Service Manual

600 Ceramic Cooktop Touch

AUPL-VCR4T

Wiring Diagram

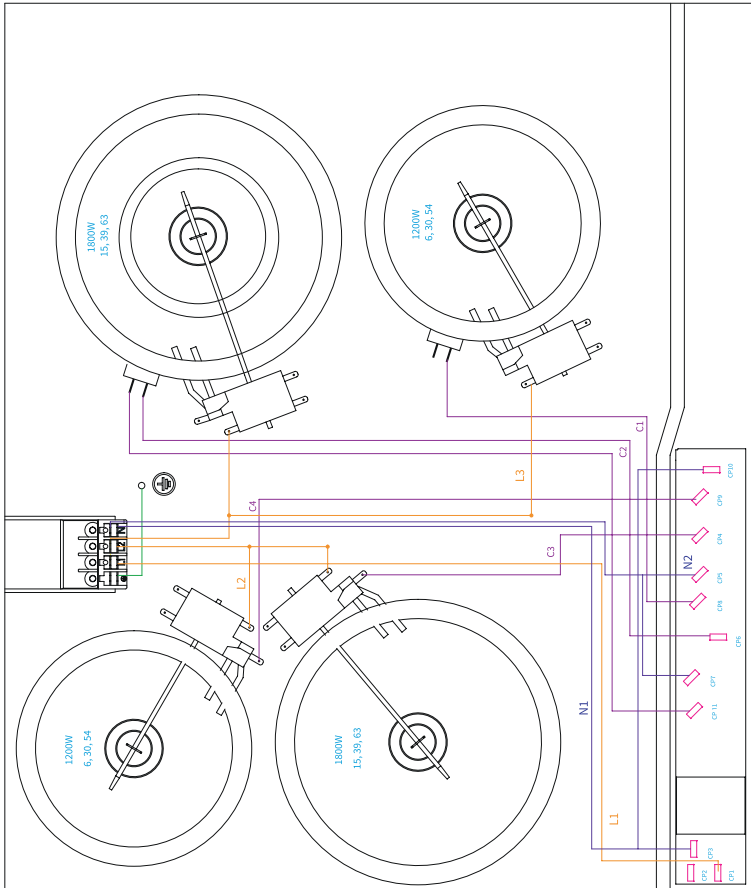
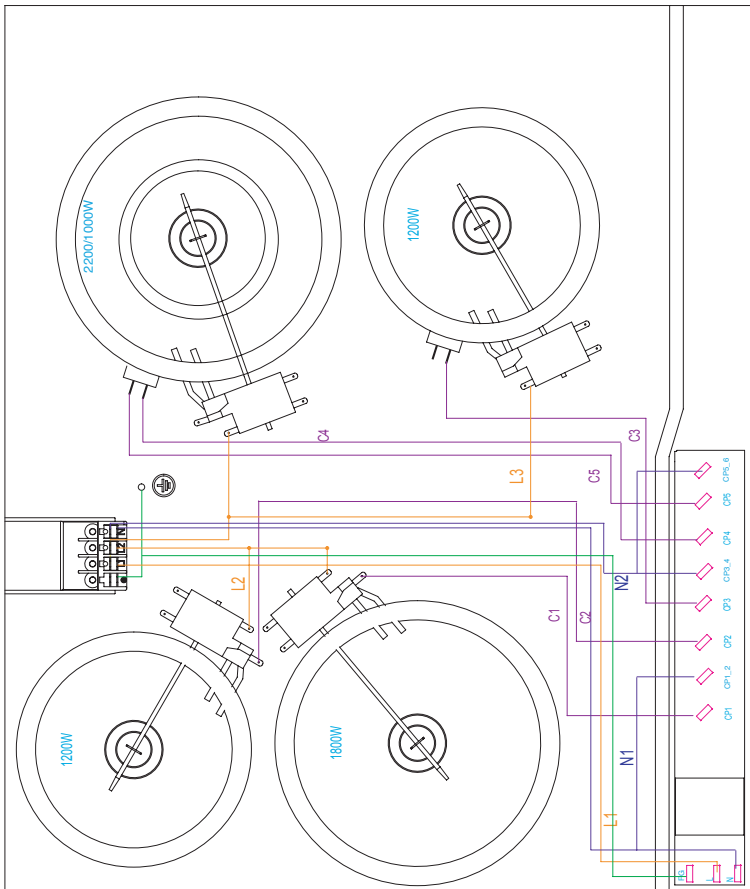
****NOTE:** New PCBs were adopted from Product Serial Number MD-07653-00XXX.

Main PCB Assmebly (2299544 > 2299558*)

Display / Touch Control Board Assembly (2299545 > 2299559*)

These new boards* are not individually suitable for hobs with previous serial numbers and vice versa.

However, if these two boards are replaced as a pair, they are suitable for all generations of cookotps.

Please refer to relevant wiring diagram in the following pages.

up to S/N MD-07653-00XXX

from S/N MD-07653-00XXX
